**City of Lake Elmo Parks Commission
3800 Laverne Avenue North
June 15, 2020 6:30 PM**

TO: Parks Commission
FROM: Ben Prchal, City Planner
AGENDA ITEM: **Bruggeman Builders Open Space PUD** – 2500 Manning Avenue – Concept PUD Review
REVIEWED BY: Ken Roberts, Planning Director

To: Ken Roberts, Planning Director Re: Bruggeman Open Space PUD (2500 Manning Ave)
Cc: Chad Isakson, PE, Assistant City Engineer Concept Plan Review
From: Jack Griffin, PE, City Engineer

Re: Schiltgen Property
Concept Plan Review

CONCEPT PLAN
OPEN SPACE NEIGHBORHOOD

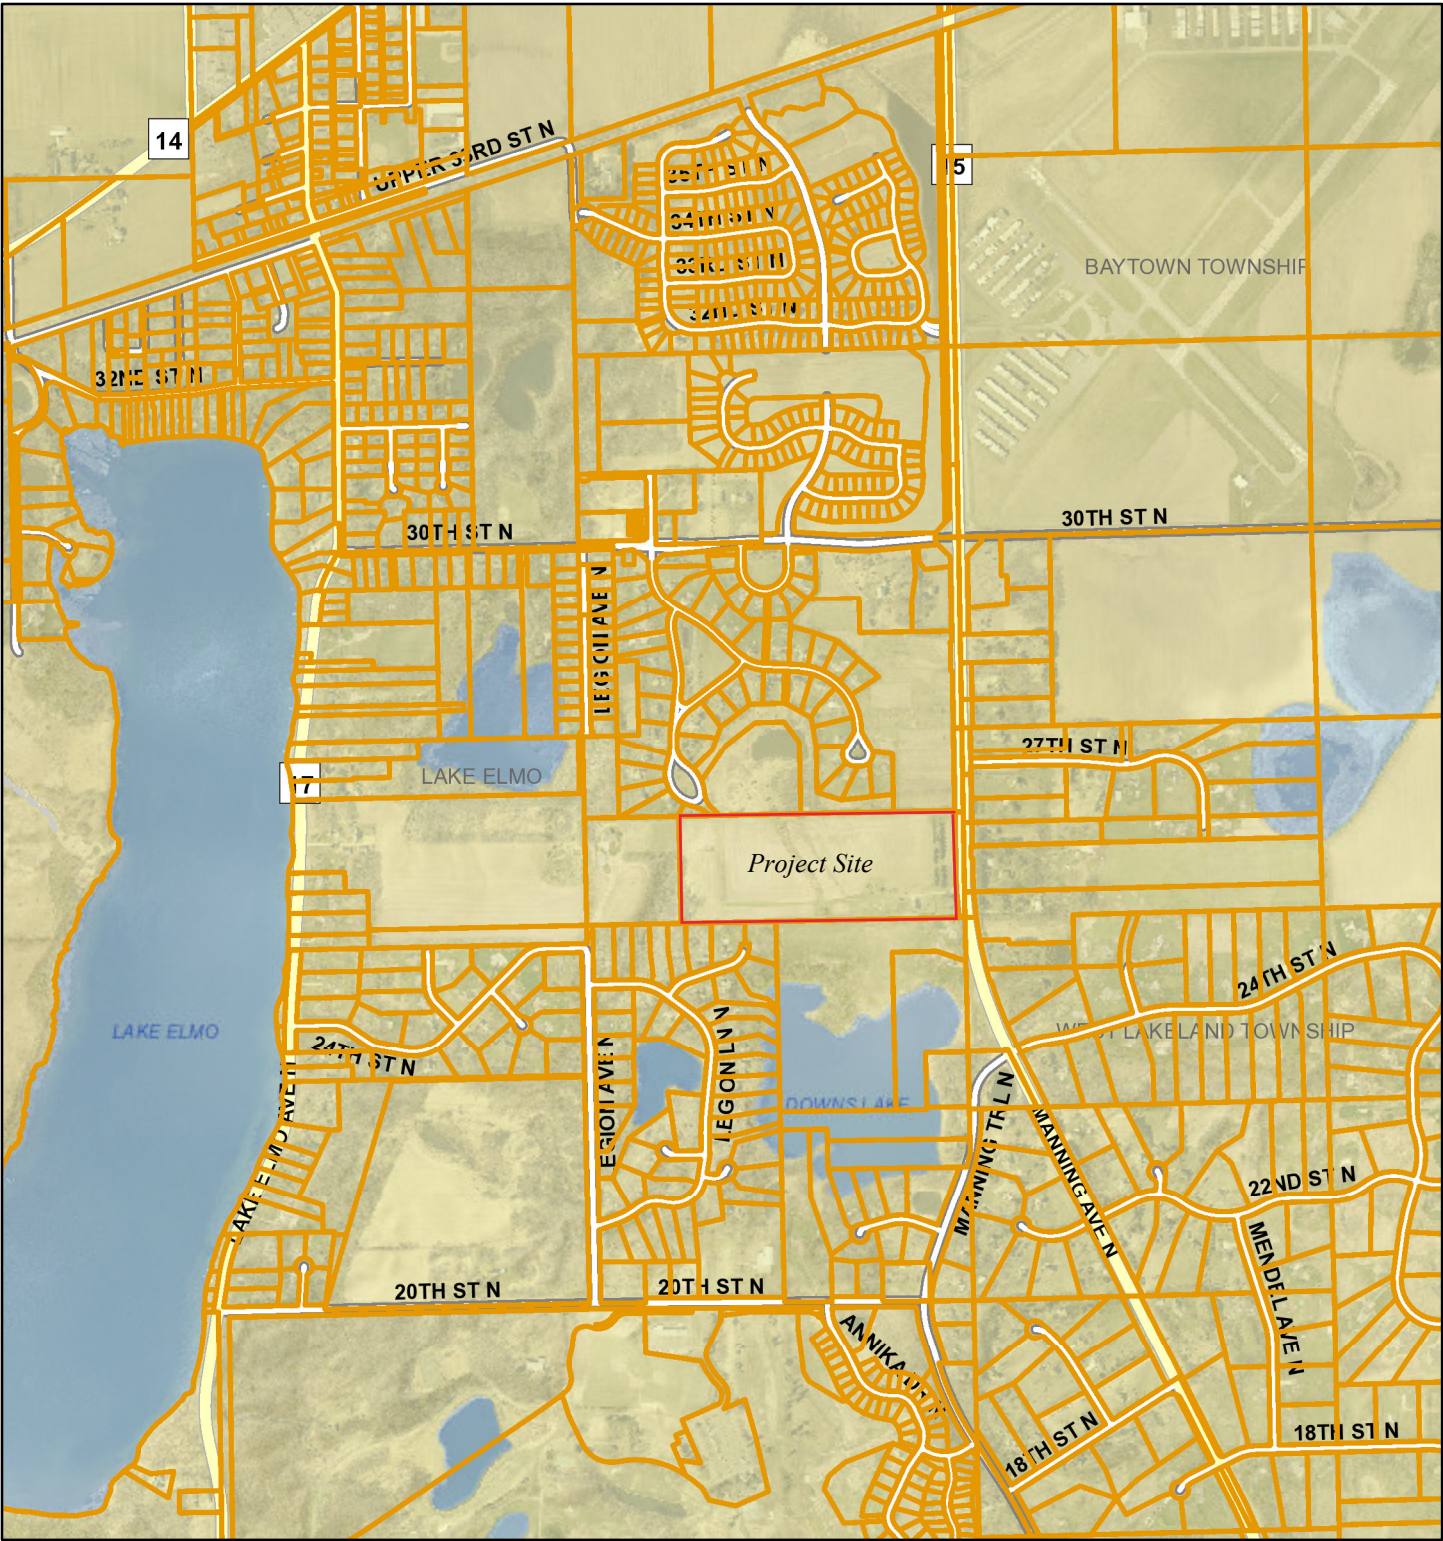
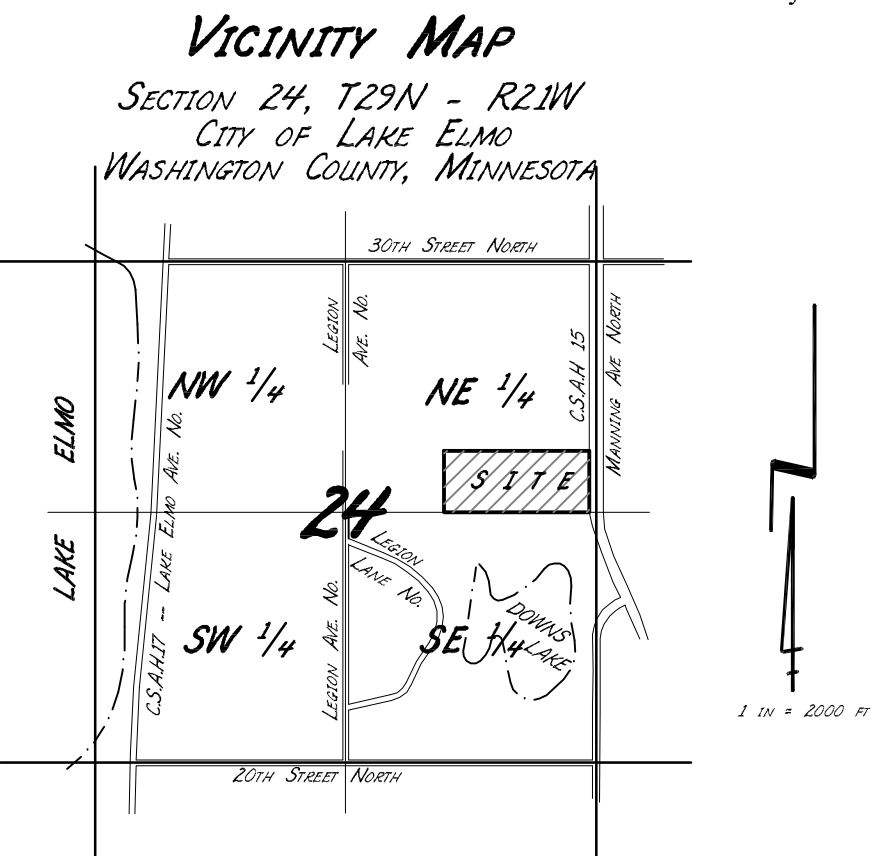
- Manning Avenue right-of-way. Additional right-of-way must be dedicated along Manning Avenue to provide 90-feet of right-of-way from the Manning Avenue centerline. The proposed plan only shows 60-feet.

- Local Street Access Improvements. The local street connection at Manning Avenue should include a short length of wider street to provide dedicated right and left turn lanes onto Manning Avenue.

- Manning Avenue Trail. The developer will be responsible to construct a 10-ft. wide bituminous trail along the frontage of Manning Avenue consistent with the Washington County trail plans.

- A residential street stub will be required to the southerly plat limits as shown. The stub location must be coordinated with the property owner, and both the right-of-way must be platted and the street constructed as part of this development. If the street is not required to be constructed as part of this development, this street connection is likely to not be completed as planned.

- The application should be revised to show both a primary and secondary ISTS system for each lot and both systems must be fully located on the lot it serves (no common areas).

- The Concept plan must be revised to show all septic systems meeting all setback requirements, including 10-feet from all property lines and 20-feet from all structures. Setbacks should be dimensioned and labeled on the revised plans.

- The site plan shows one storm water pond area located on Lot 1, Block 3. The Site plans must be revised to show all storm water basins to be located on dedicated Outlots. The Stormwater Facility Outlots must fully incorporate the 100-year HWL, 10-foot maintenance bench and all maintenance access roads. Preliminary drainage calculations should be performed as part of revising the concept plans for resubmittal to allow for adequate storm water basin site planning.

- The site plan shows one storm water pond area located within an existing storm water drainage path. It is likely that the storm water pond will need to be located to allow for the continuation for the existing drainage path.

CONCEPT PLAN 5

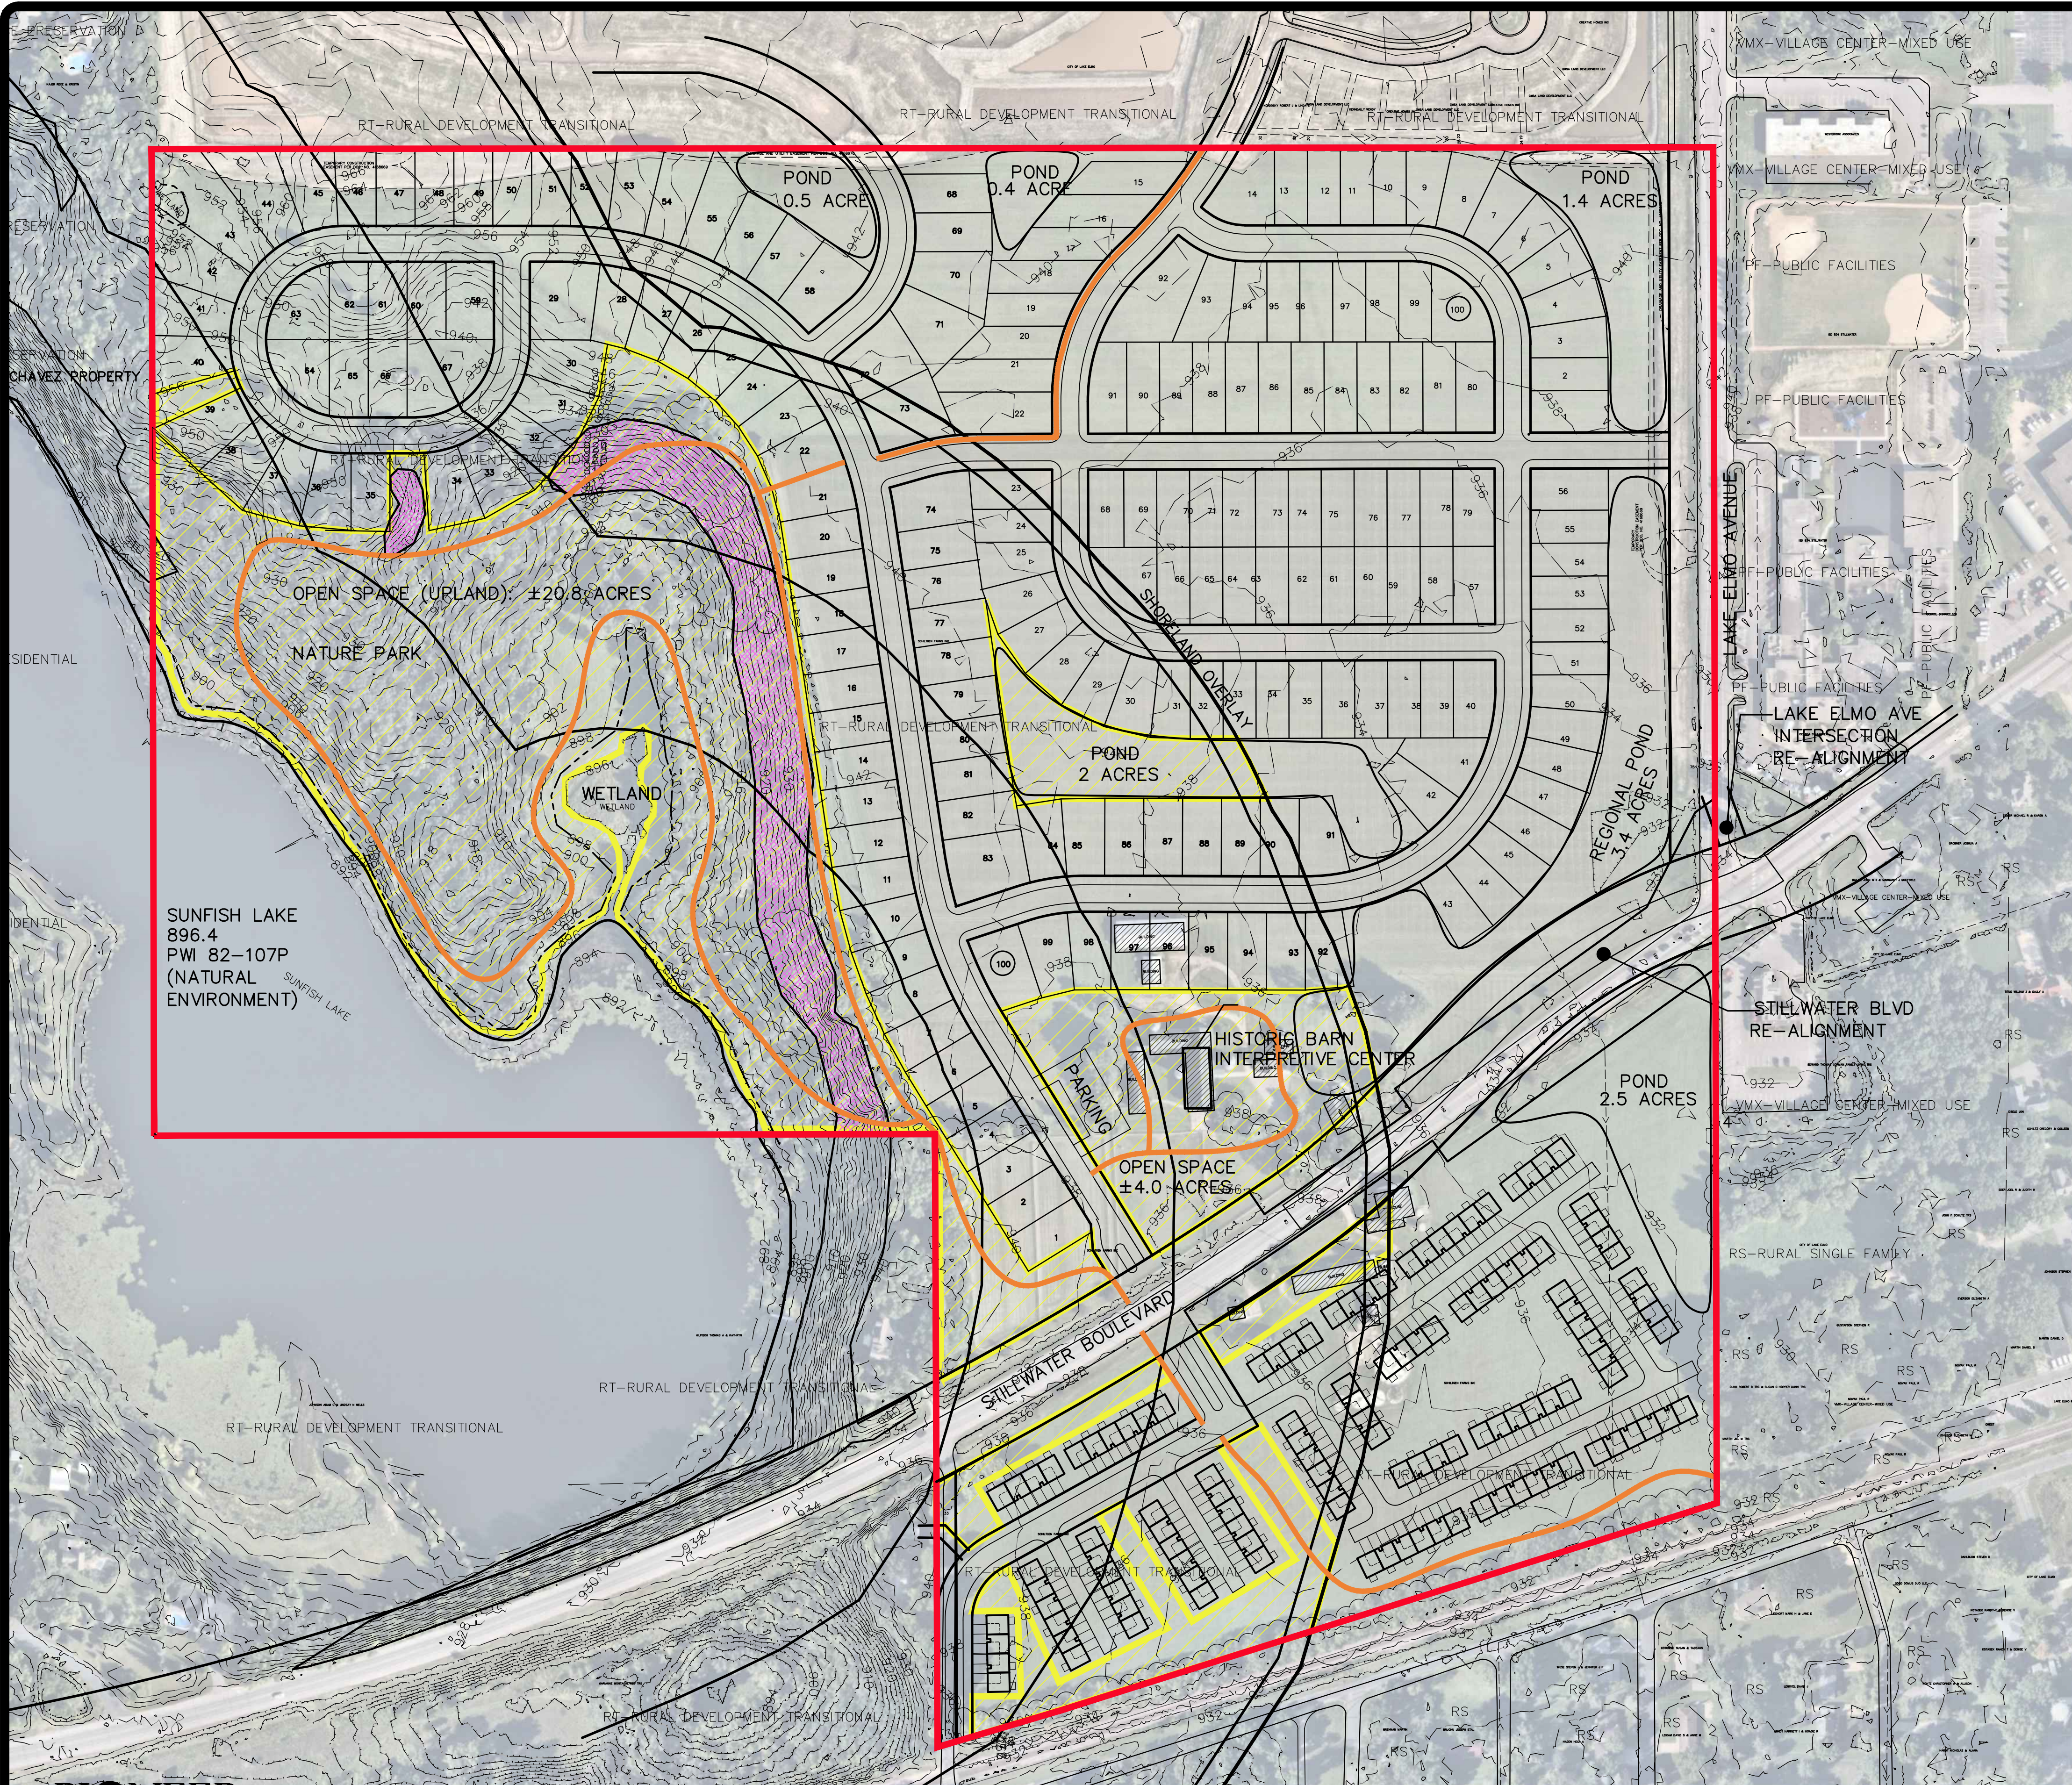
- CSAH 14 and CSAH 17 Intersection reconfiguration. The concept plans should be revised to incorporate the proposed reconfiguration of the CSAH 14 and CSAH 17 Intersection improvements, including right-of-way dedications and site access.

- Access Management. The concept plans should be revised to incorporate the County approved access locations along CSAH 14 and CSAH 17.
- Intersection Improvements. The applicant will be responsible to construct all intersection and turn lane improvements along CSAH 14 and CSAH 17 as required by Washington County. These improvements must be completed at the developer's cost.

- Pedestrian facilities: The concept plans should be revised to incorporate bituminous trails along CSAH 14 and CSAH 17.

- The concept plan shows a Regional Pond at the intersection of CSAH 14 and CSAH 17 as required in the City CIP. The capacity and area dedicated for the required regional pond should be verified with the city and the plans updated accordingly.
